# SITE AUDIT REPORT

Beaches Link and Gore Hill Freeway Connection  
Project, NSW

21313 SAR199

**Re: Site Audit Interim Advice No. 2 (IA2) – Review of GHD (March 2022) Framework Sampling, Analysis and Quality Plan, Beaches Link and Gore Hill Freeway Connection Project**

Figure 1 Overview of the construction support sites (TiNSW, 2020b)

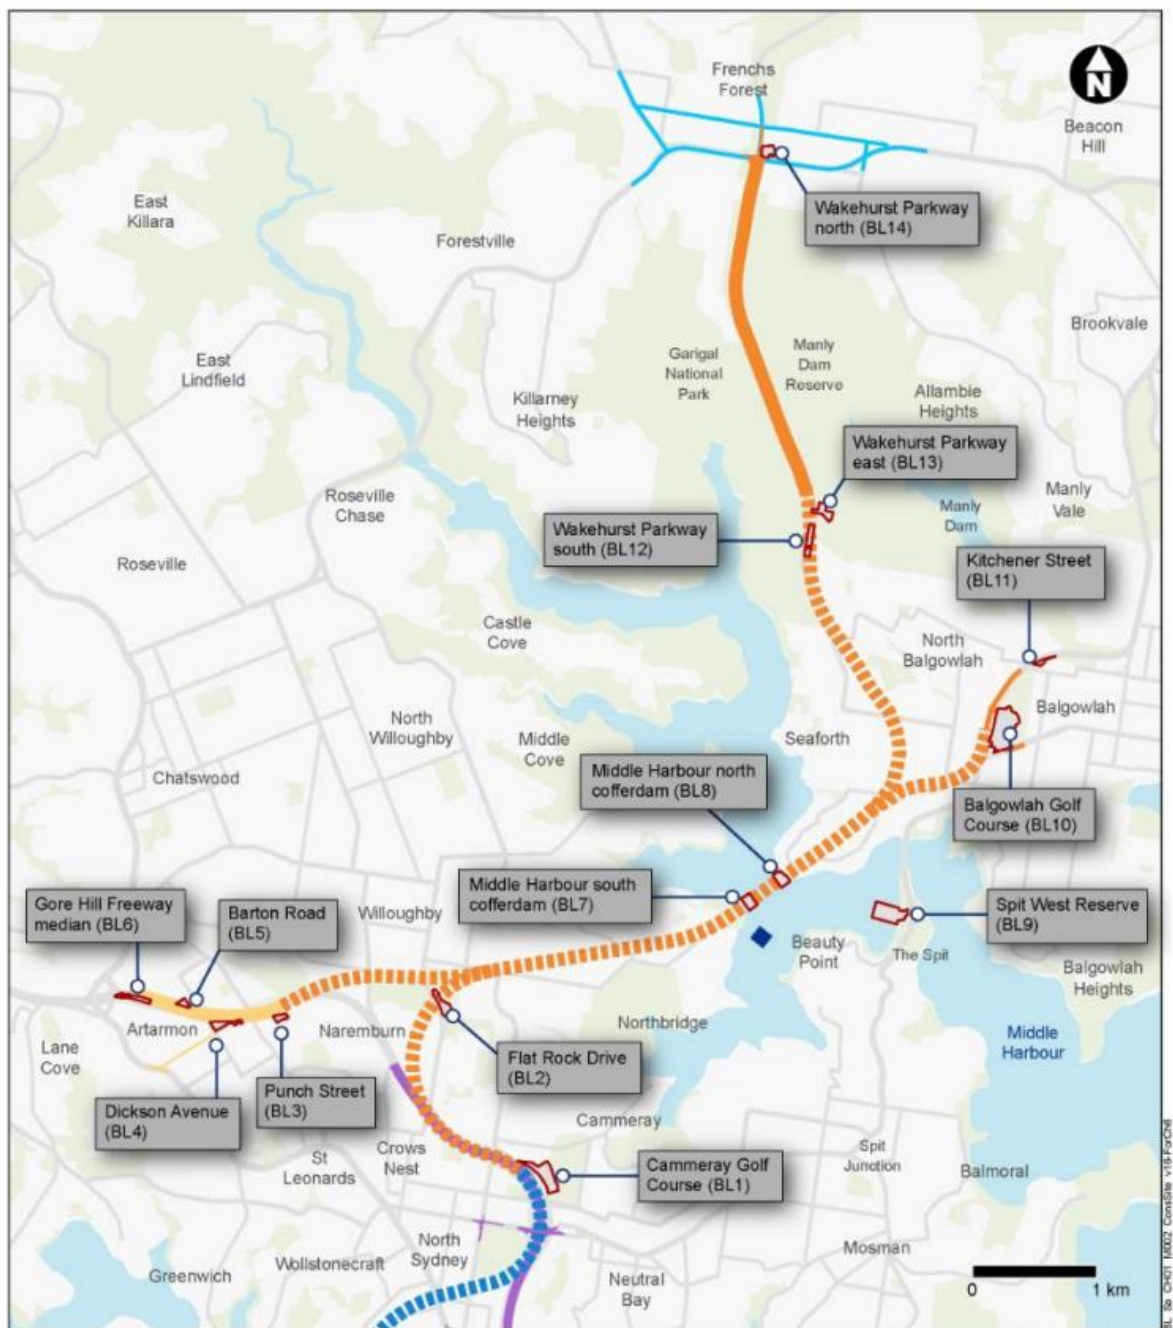
- b. Table 1. It is understood that the EIS, Appendix M – Contamination assigned a risk ranking of ‘low’ for the AEI located at Kitchener Street, Balgowlah. The EIS notes that this ‘n/a’ AEI is ‘adjacent to construction support site footprint BL11’. However, Figure 1 of the Framework SAQP indicates that this is a ‘Construction Support Site’. Can this please be clarified? Please also consider including a definition for ‘construction footprint’ and construction support site’ to differentiate between the two features.

- a. Reference has been added to the risk assessment matrix included in Section 5 of Appendix M (Contamination) to the EIS.
  - b. Figure 1 in the Framework SAQP is taken from the EIS and shows all construction support sites proposed to be used for the BLGHFC project, whether they are related to an AEI or not. Figure 2 has been updated to show all AEIs identified in the EIS as moderate to high risk of contamination, as well as their categorisation. Definitions have been added to the glossary for 'construction footprint' and 'construction support site' to differentiate between the two project features.

**Figure 2** AEIs with moderate to high risk of contamination (TfNSW, 2020b)<sup>1</sup>

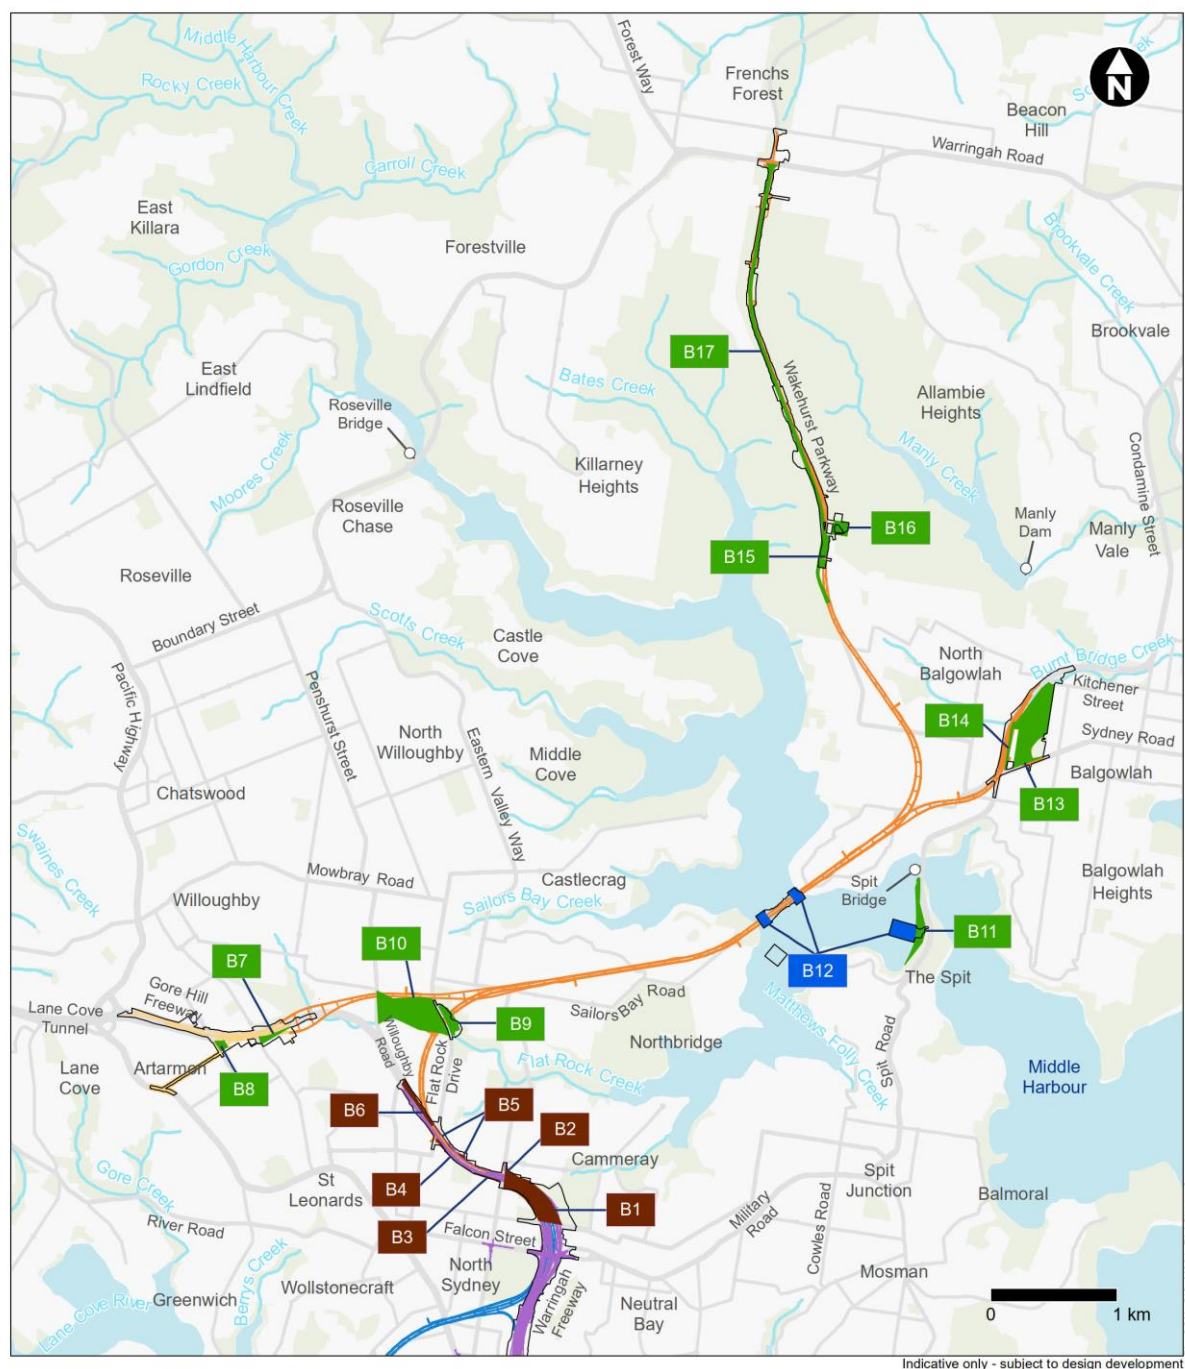
29. Appendix A – Figures 2-7.
    - a. Please include the names of the suburbs relevant to each AEI.
    - b. Please consider amending the figure titles to read “Moderate to high risk ranked sites requiring further investigation’.

- d. Figure 2 displays all Areas of Environmental Interest (AEIs) identified within the environmental impact statement (EIS) in a single figure.
  - e. Section 4 requires future site-specific SAQPs consider the significance of the lateral tunnel position and depth relative to AEIs.
